A Review of the Oconee-3 Probabilistic Risk Assessment

External Events, Core Damage Frequency

Brookhaven National Laboratory

NUREG/CR-4374
BNL-NUREG-51917
Vol. 2

Figure 2.2 Event tree for sequences initiated by turbine-building flooding.
(OPRA Figure 9-77)

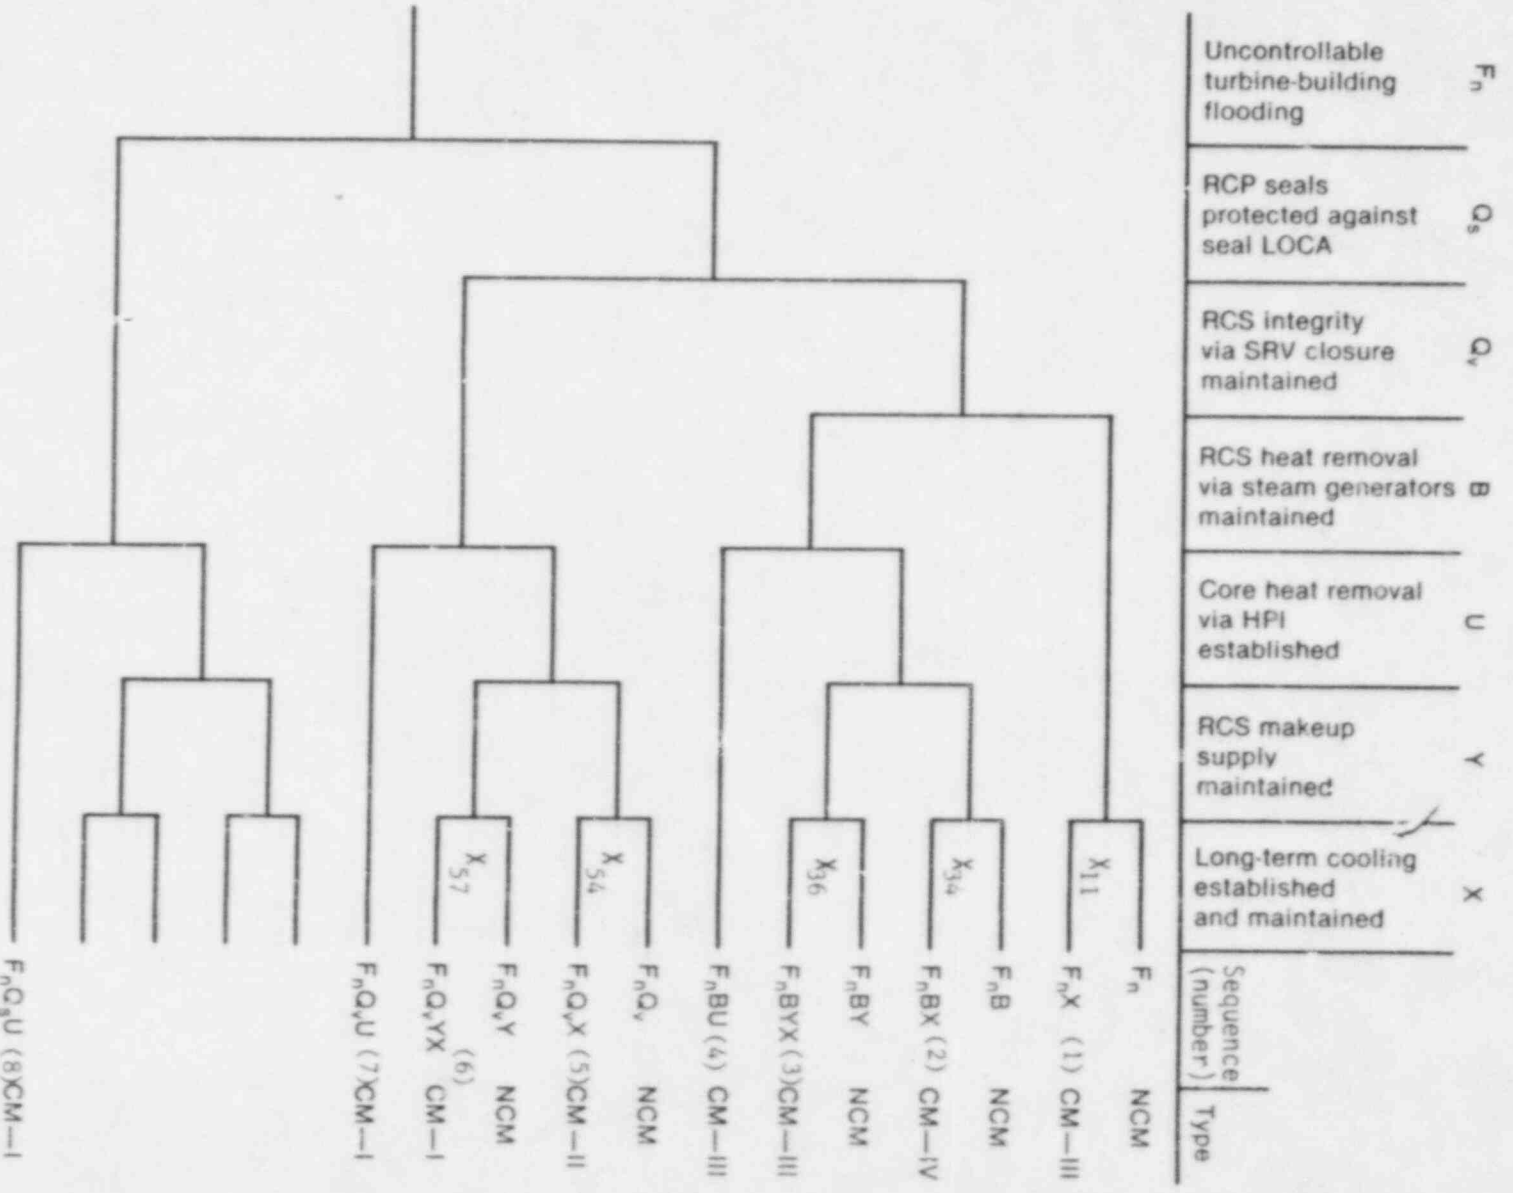
Eight event tree sequences initiated by a turbine building flooding are considered in the OPRA and are shown in Figure 2.2 (OPRA Figure 9-77); this review did agree with the event tree used in the OPRA.

BNL did not change the main accident sequences. However, a split between the short-term (~2 hours) and late (~12 hours) components of X36 and X57 (long-term cooling) is more realistic; this split was used in the BNL review. As a consequence of this split, sequence No. 6 contributes to bins I and II, and sequence No. 3 contributes to bins III and IV; the contributions to bins I and III are dominant, as presented in Appendix B. Note that the eight sequences in Figure 2.2 were used in the BNL quantification for each sequence. After the minimal cut sets in each segment were obtained with the SETS code, the splits of the sequences 3 and 6 were performed.

The heading of B sequence in OPRA is inappropriate. BNL considers this sequence to be part of sequence No. 1 of Figure 2.2. In general, the results are similar, but BNL has made two changes that compensated each other: 1) consideration of operator error in the recovery of long-term ASW suction and 2) consideration of some recovery of SSF, feedwater, or BWST because longer grace times are available.

Figure 2.3 Event tree for failure to maintain long-term SSF ASW suction after a flood.

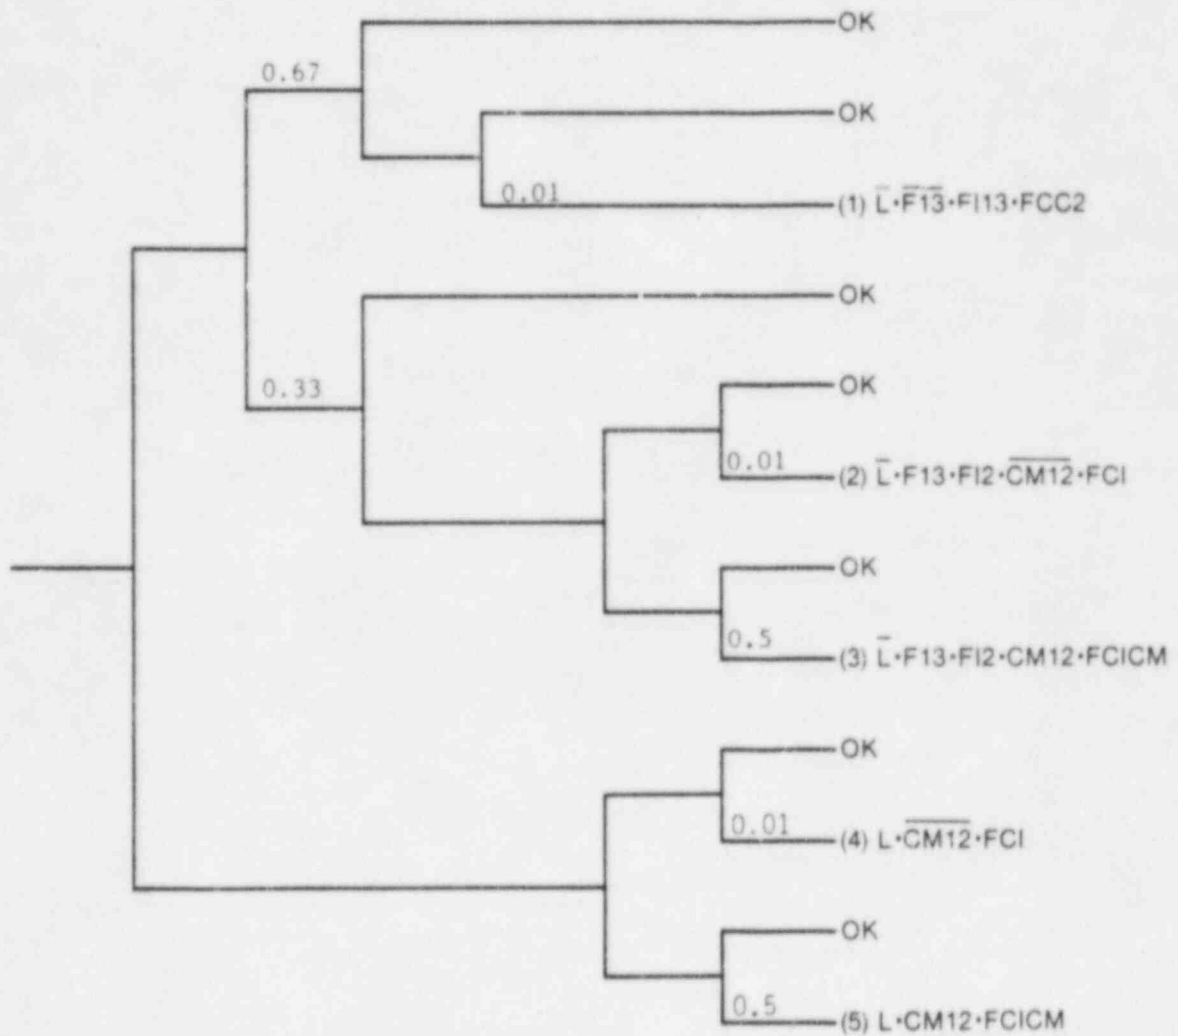
The sequences contributing to bins II and IV include a term for failure to maintain a long-term suction for the SSF ASW. The OPRA has analyzed this event separately, using the event tree shown in Figure 2.3. Table 9.41 of the OPRA provides the data used in their quantification. BNL reviewed this analysis and considers it to be a good representation of the main actions necessary to isolate the flood in the long term, and also to maintain long-term suction to the SSF ASW. A discussion of the top events in Figure 2.3 follows:

The "ASWLTF" is the result of the quantification of the event tree in Figure 9-93 of OPRA, shown in Figure 2.3 of this report. This figure, with the values given here in Table 2.7, can be used for its quantification. The ASWLTF is the conditional probability of losing ASW long-term suction given any flood initiator.

The reduction by a factor of 2 in the BNL review results is because the frequency of FLN is lower in the BNL reevaluation, and because in sequences [2] and [3] SFAPPSLN for FLN is used in OPRA, rather than a value about one third smaller, which results from using OPRA, Table 9.41 and Figure 9.93, for FLII.

Figure 3.2 O'Connell study seismotectonic model.

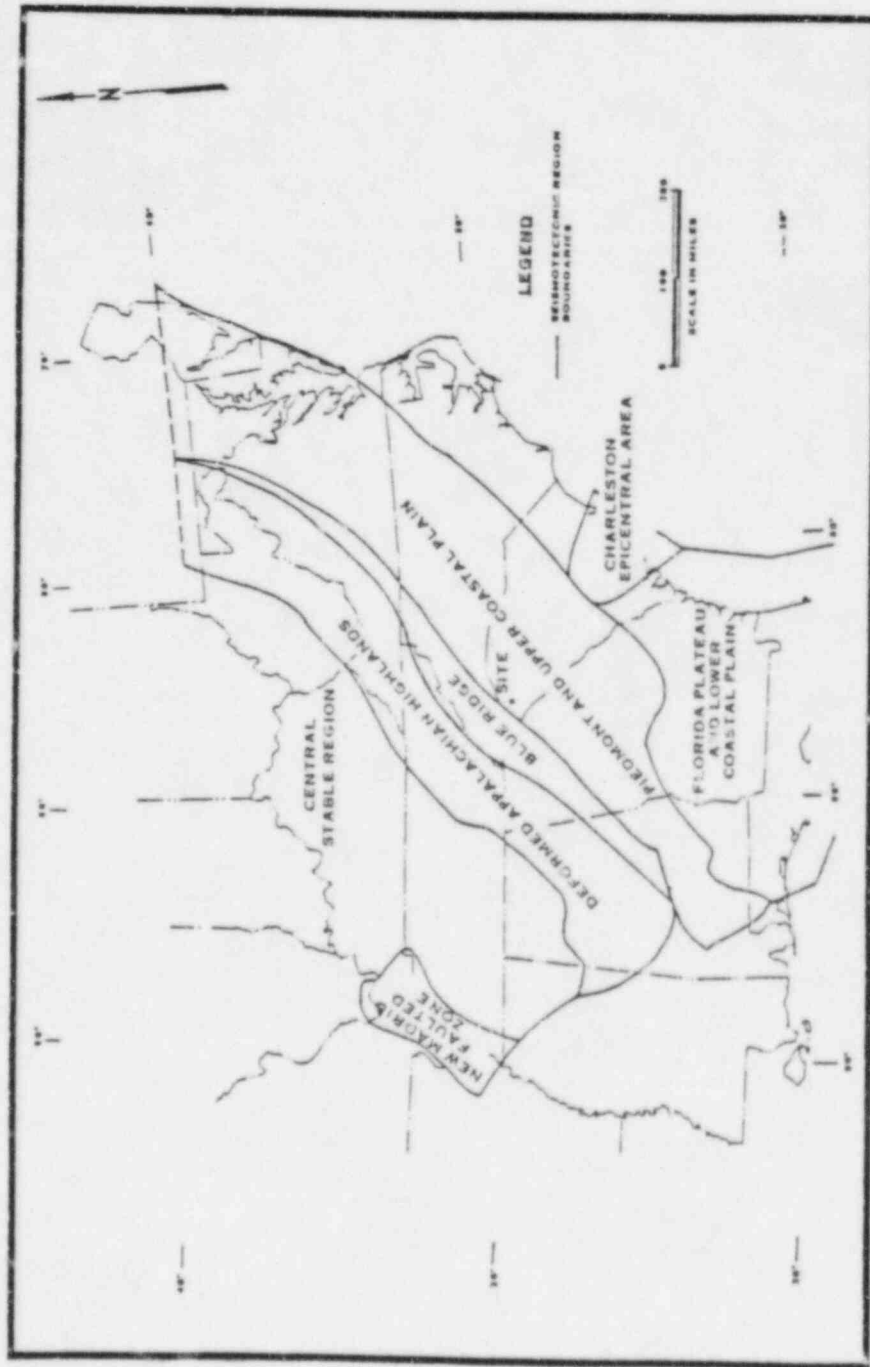
Figure 3.2 shows the seismotectonic model used in the OPRA to evaluate the ground motion hazard. This model was assigned a 1.0 weight, suggesting that there are no other realistic tectonic models that should be incorporated in the analysis or that all other relevant tectonic models are reasonably embodied in the model in Figure 3.2. The former view seems inappropriate, given that other studies available at the time²⁰⁻²² offer a number of alternative seismotectonic models. The latter view is a matter of practical concern since the only way to actually evaluate whether the results of other sources are implicitly included is to run the actual cases.

Figure 3.7 Comparison of the best estimate ground motion models from the LLNL ground motion panel for magnitudes 5 and 7 and the Ocone attenuation relationships.

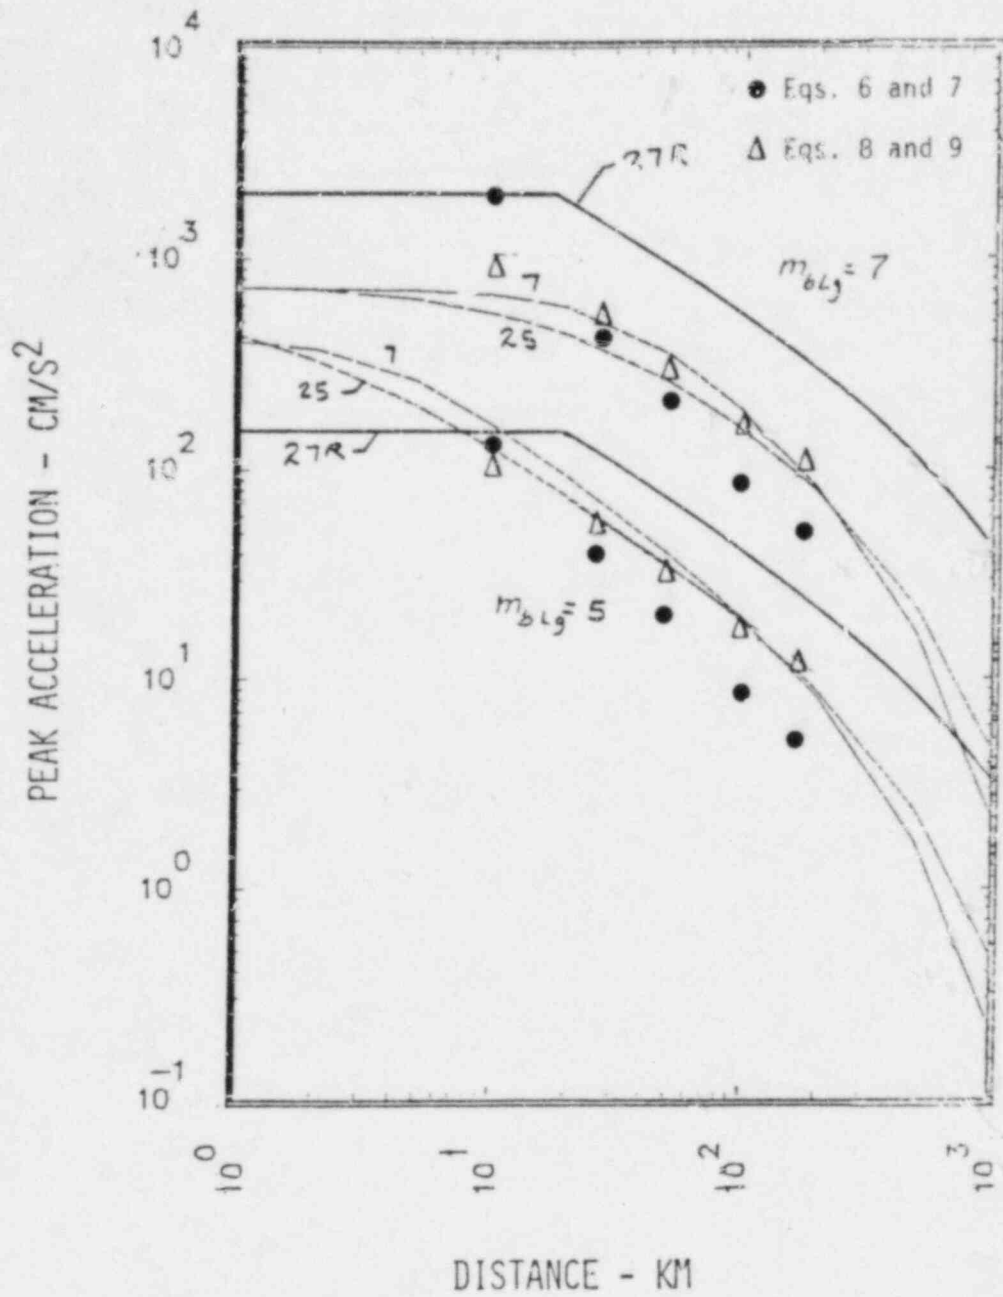
In Figure 3.7, the two attenuation models used in the Oconee study are compared to the best-estimate ground motion models (for rock) selected by the experts in the SHCP⁵. To plot the curves, the relationship, $MMI = 2 M_b - 3.5$ was used to convert MMI to magnitude. Figure 3.8 presents a similar comparison with other models provided by the ground motion experts.

Figure 3.8 Comparison of the Oconee attenuation models and other models provided by the SHCP ground motion experts.

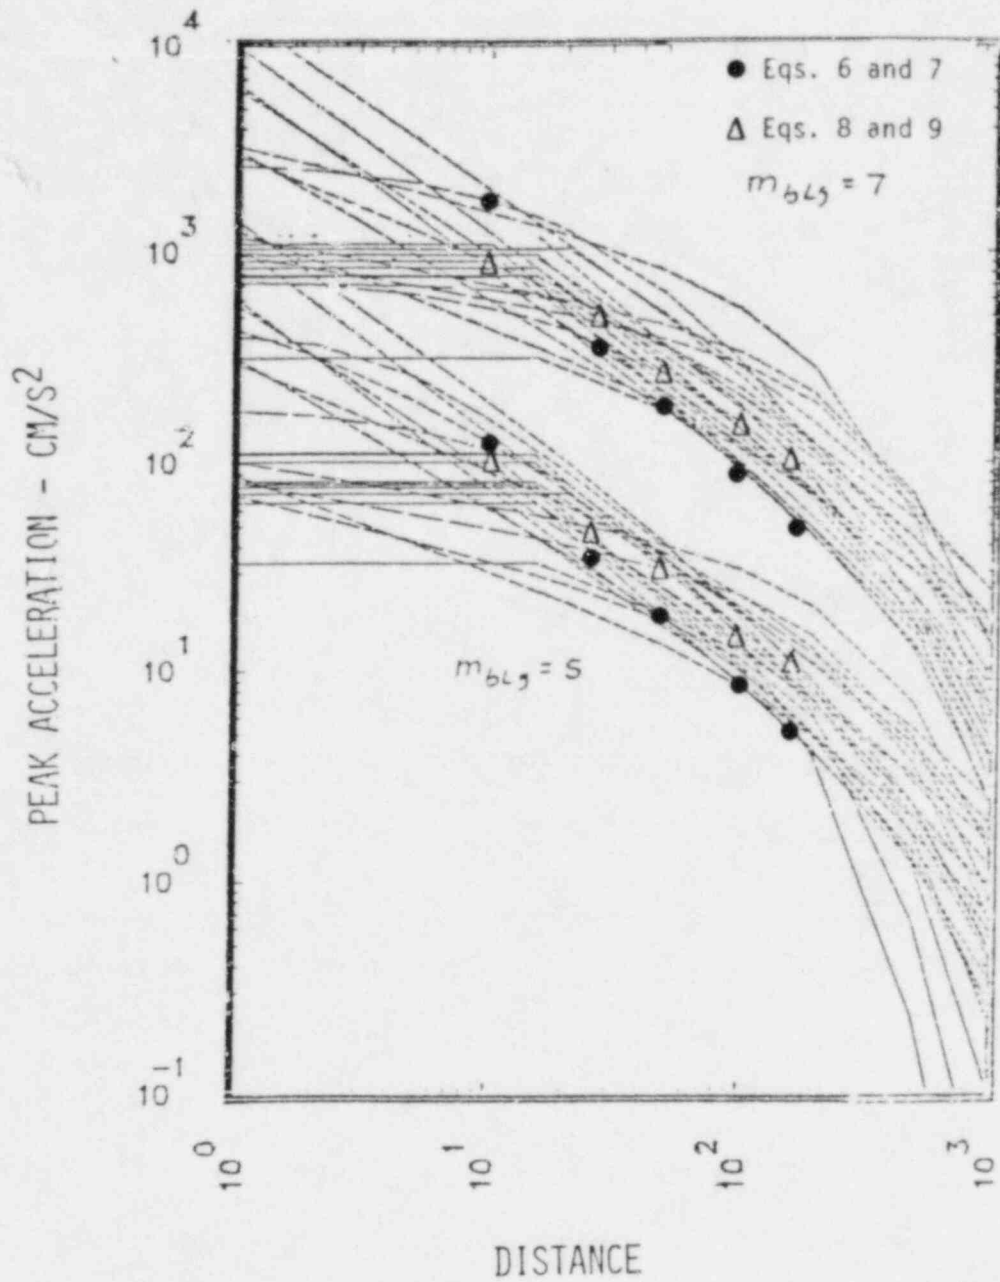
Figure 3.8 provides a different comparison. In this figure it can be seen that considerable variability can exist in the assessment of ground motion. In particular, the Oconee study incorporates only a part of this variability. A site-specific analysis, however, may not be expected to have as large a variability as a regional study, such as the SHCP. However, as shown in Figure 3.8 for magnitude 7.0, where the dispersion among the experts is great, the Oconee study accounts for only a fraction of the total variation.

Figure 3.10 Comparison of the 1976 and 1982 USGS studies and the mean Oconee seismic hazard curve.

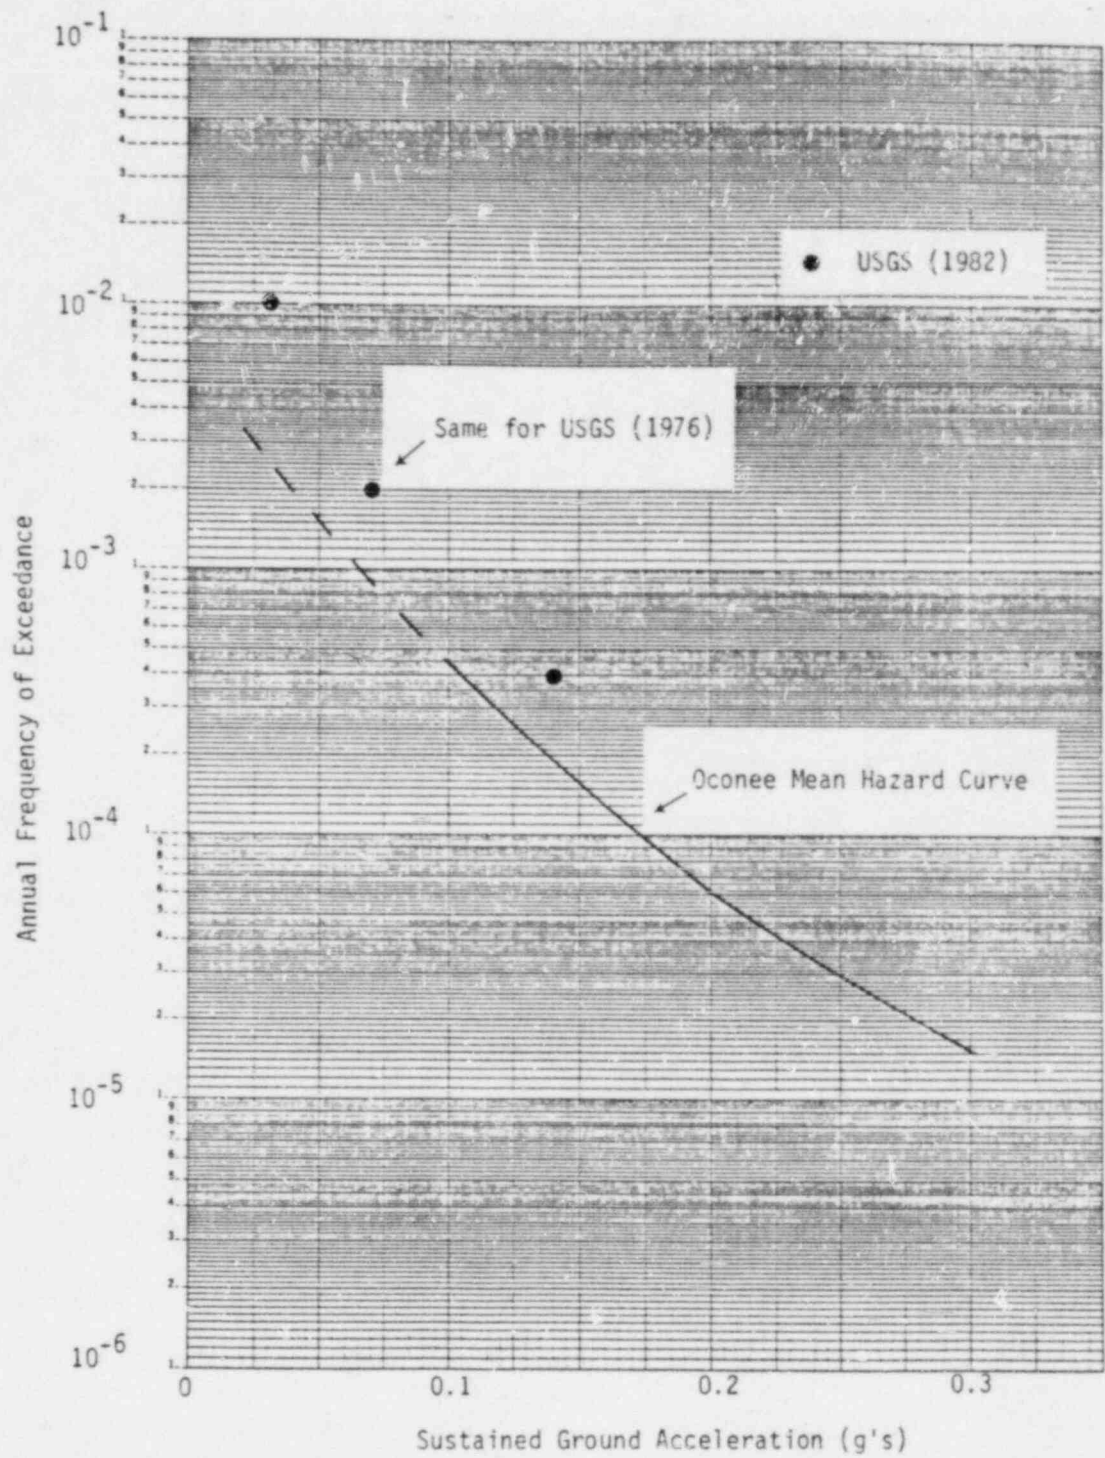
Figure 3.10 compares the USGS 1976 and 1982 hazard curves with the mean Oconee hazard curve. It is difficult to make a true qualitative comparison between these studies since the USGS studies do not account for the variability in ground motion. If they had, their results would be higher.
